**AGENDA FOR REGULAR MEETING
VILLAGE OF TINLEY PARK
PLAN COMMISSION
February 19, 2015 – 7:30 P.M.
Council Chambers
Village Hall - 16250 South Oak Park Avenue**

**ITEM #1 MAHER FUNERAL HOME (JOHN MAHER, PETITIONER) – 17101 71st AVENUE
– SPECIAL USE PERMIT FOR AN ACCESSORY APARTMENT, FRONT YARD
SETBACK VARIATION, AND SITE PLAN APPROVAL FOR A FUNERAL HOME
(New Item)**

PLAN COMMISSION

The Applicant proposes to convert the former Tinley Park Library, located at 17101 71st Avenue, into a new funeral home facility with a one-bedroom apartment as an accessory use. The proposed apartment use requires a Special Use Permit. As part of the Special Use process, the Plan Commission must review the proposed site plan and elevation changes.

SHEET NO.
A-1.1R

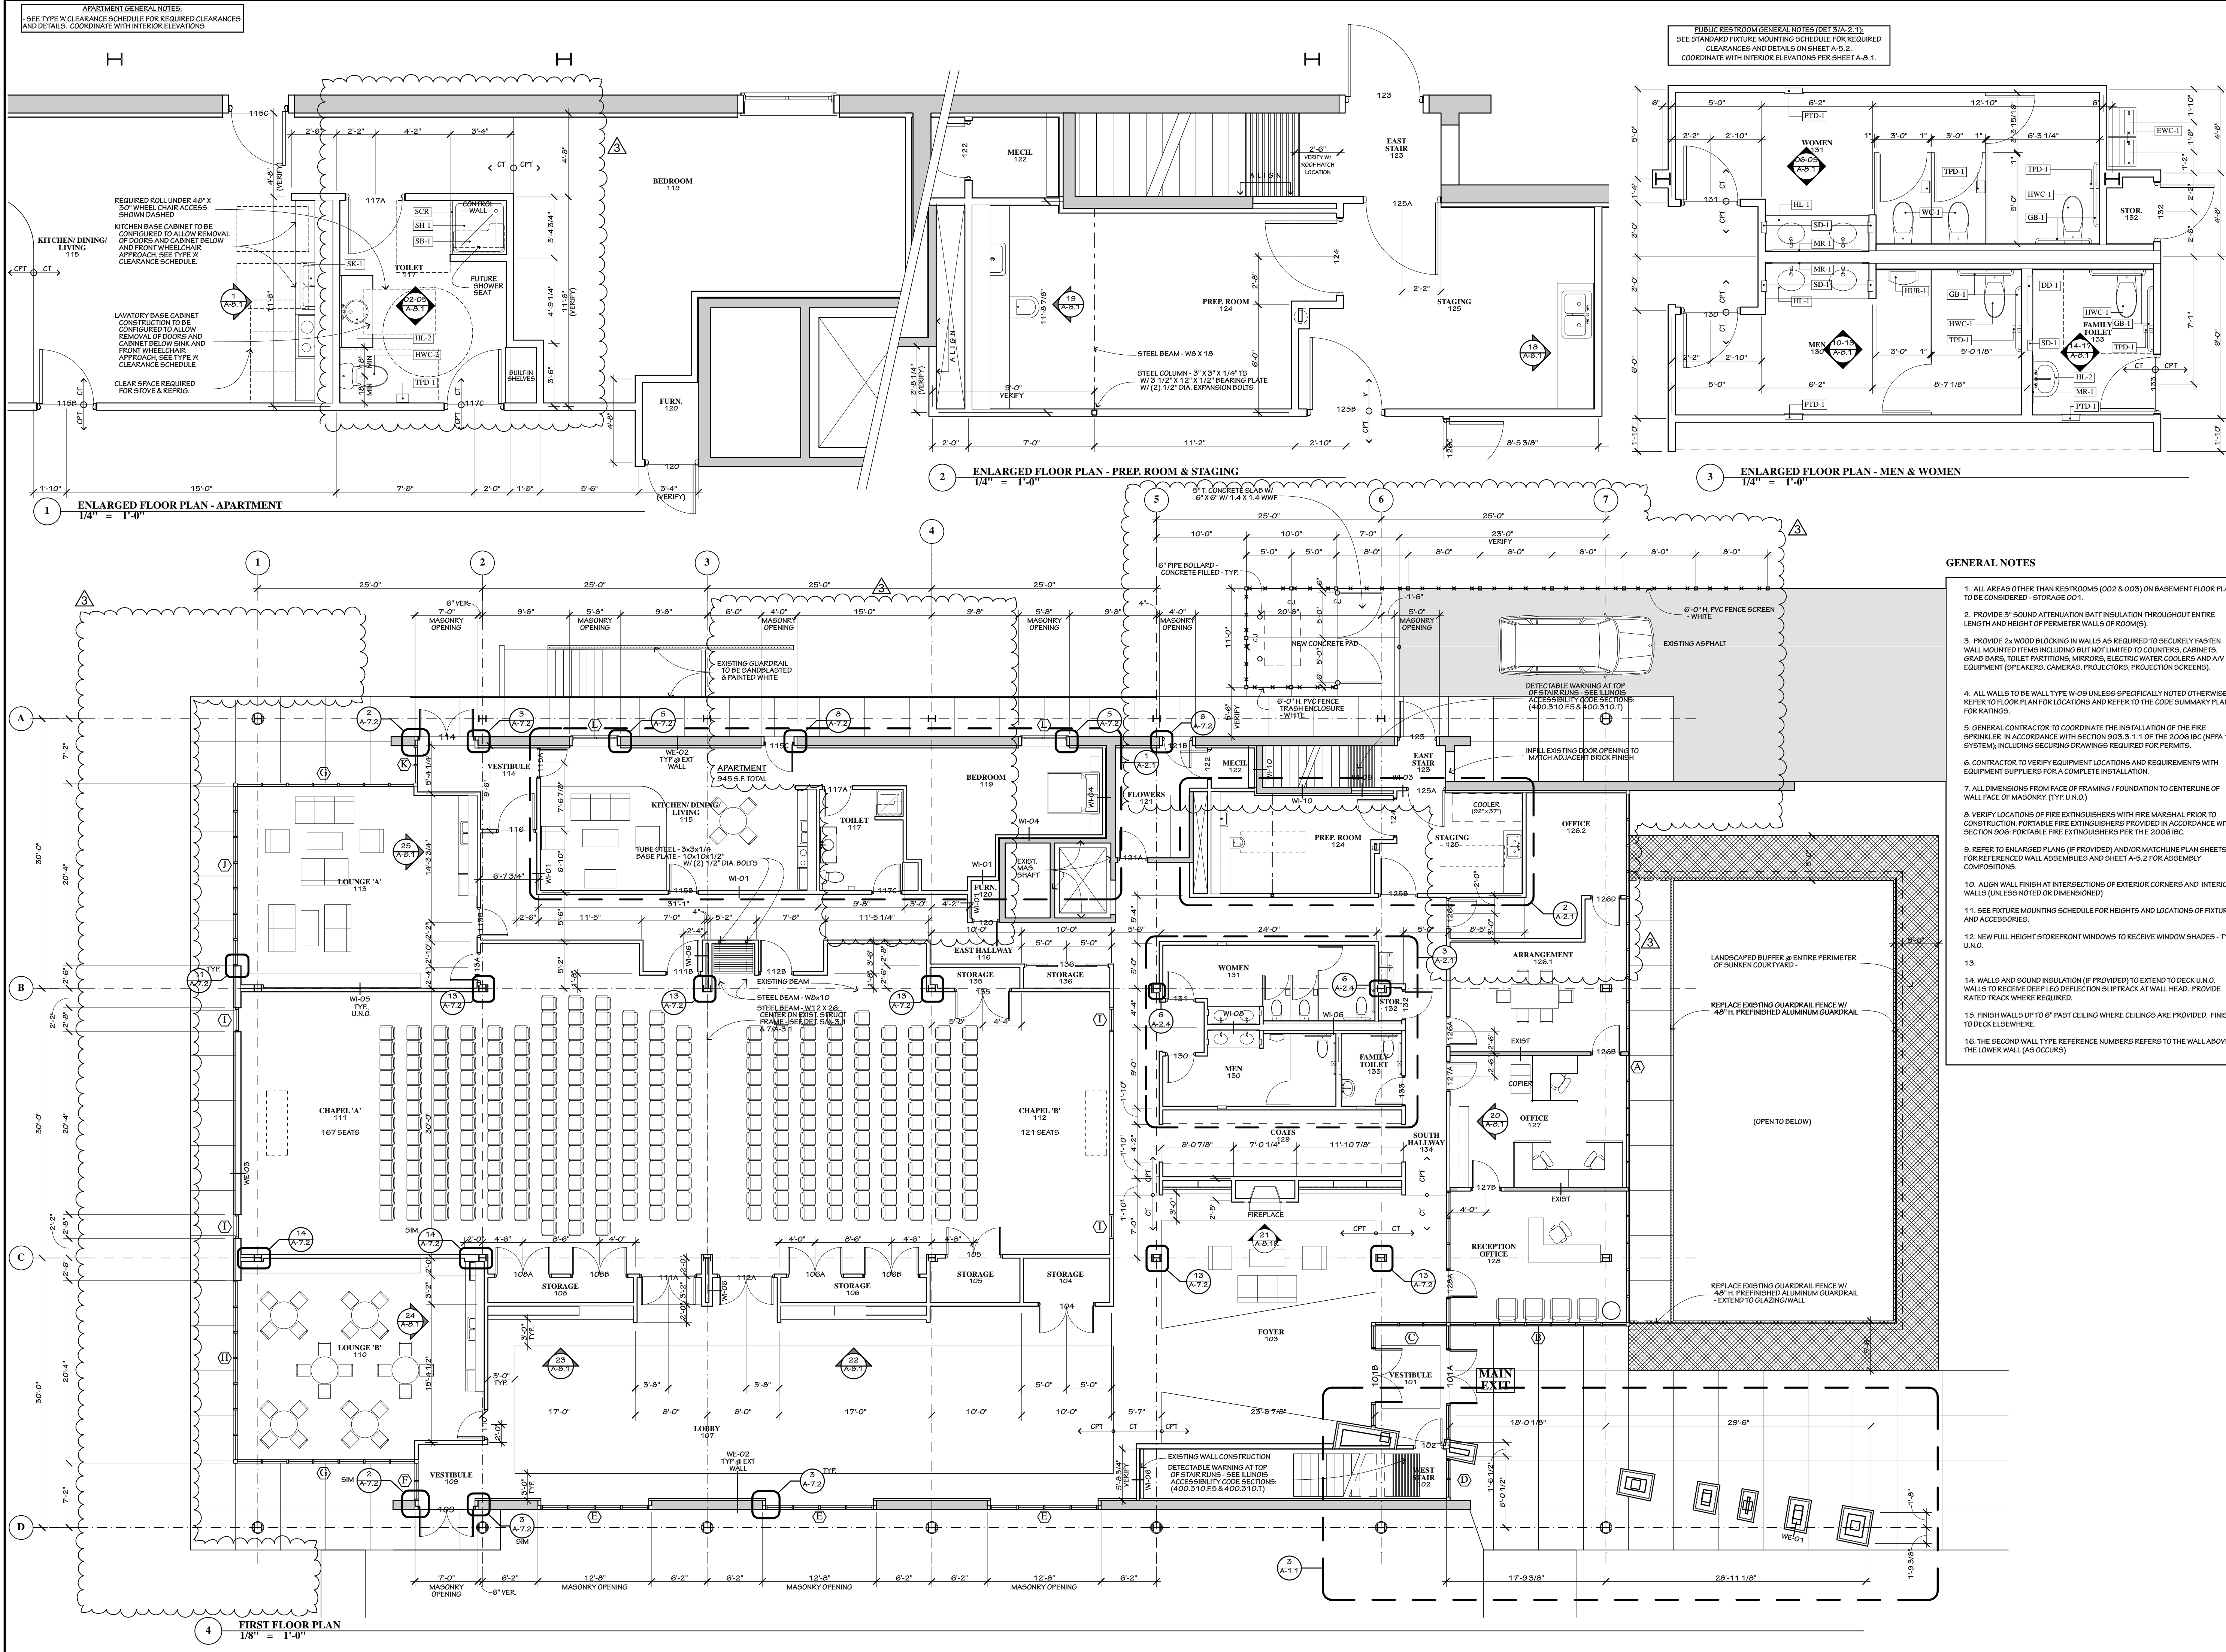
The site plan for the former Tinley Park Library is remaining generally intact. The parking lot will remain in its current configuration with two points of access to 171st Avenue. There is no curbing for the existing parking lot therefore wheel stops have been provided to protect the landscape area to the south and the drive aisle/drop off area, at the north end of the parking lot. The loading zone remains at the southeast end of the building. The open lower level terrace will also remain.

The existing parking lot configuration will remain intact and does not include curbing. Wheel stops will be installed at the south end of the parking lot to protect the landscape area; wheel stops have also been provided along the north line of parking (accessible parking area) to protect the drop-off area. The existing landscape islands are legal non-conforming in size (150 s.f. proposed vs 200 s.f. required) and lack curbing, therefore staff has expressed concern that vehicles or snow plows could damage the landscape areas if they are not planted with a significant amount of plant material.

Open Item #1: Staff has recommended additional landscaping within the islands in the hope of preventing vehicles from trespassing across the islands. The most recent landscape plan provides for six (6), 24" Gro-low Sumac. Sumac is a very hardy shrub, however staff is recommending adding 5-6 larger, hardy evergreens shrubs that are greater in height (3-4'), such as Inkberry (*Ilex glabra*) or a variety of Juniper, along with 4-6 additional Gro-low Sumac, for a total of 10-12 Sumac. In addition, staff has requested a snow removal/storage plan from the Applicant.

The proposed site plan also indicates a loading area dimensioned at 8 ½ x 72 feet at the east of the building. This area will be used for the deliveries of bodies. The Applicant has agreed to erect a 6’ PVC fence in this area. Locating the fence in this area rather than at the east property line will ensure adequate screening of this activity.

A trash enclosure will be located north of the loading area. This will provide easy access for waste services. The PVC fence that will enclose the loading area will also serve as the screen for the trash enclosure. A masonry enclosure cannot be constructed in this location due to the location of sanitary and storm service lines.

A-4.1R

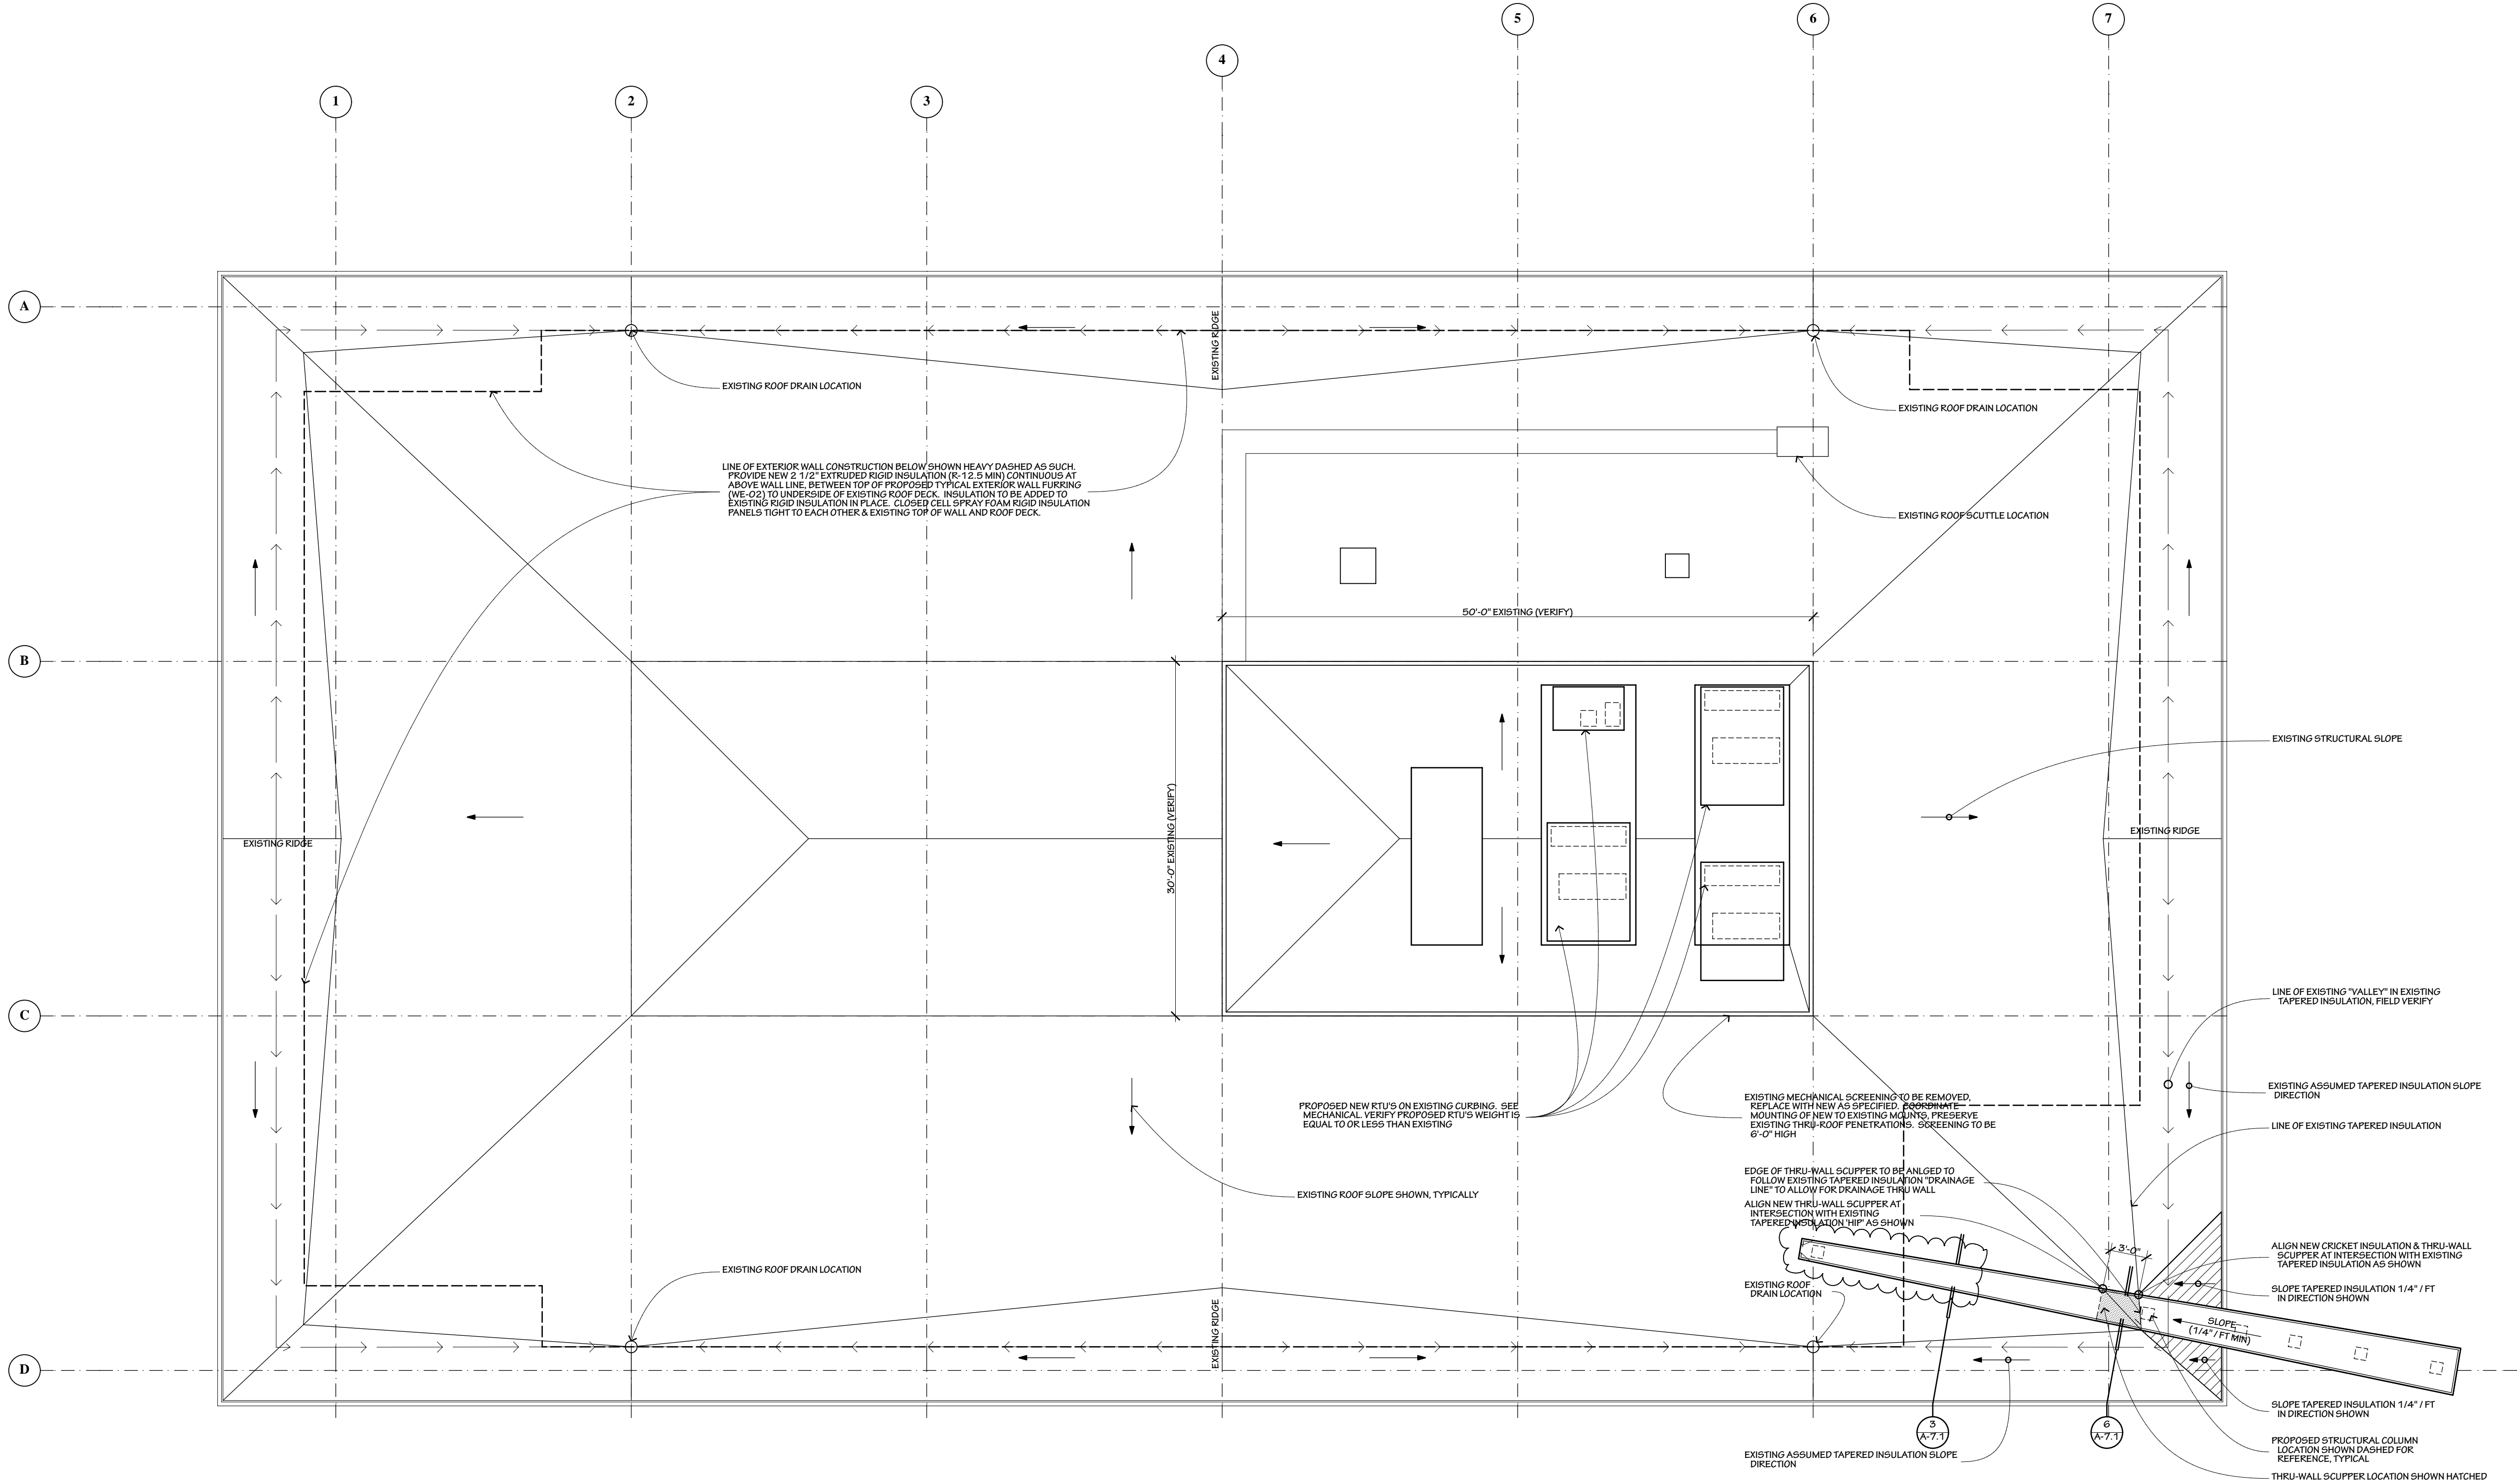
The architect has proposed all new mechanical systems and therefore the existing rooftop units will be replaced. The new units will be smaller in size (4'9") and will utilize the existing metal louvered screen. Staff has not been able to verify the height of the existing metal louvered screen

Open Item #4: *Staff has requested information on the height of the rooftop mechanical screen from the project architect. The goal is to ensure all rooftop mechanical units are properly screened.*
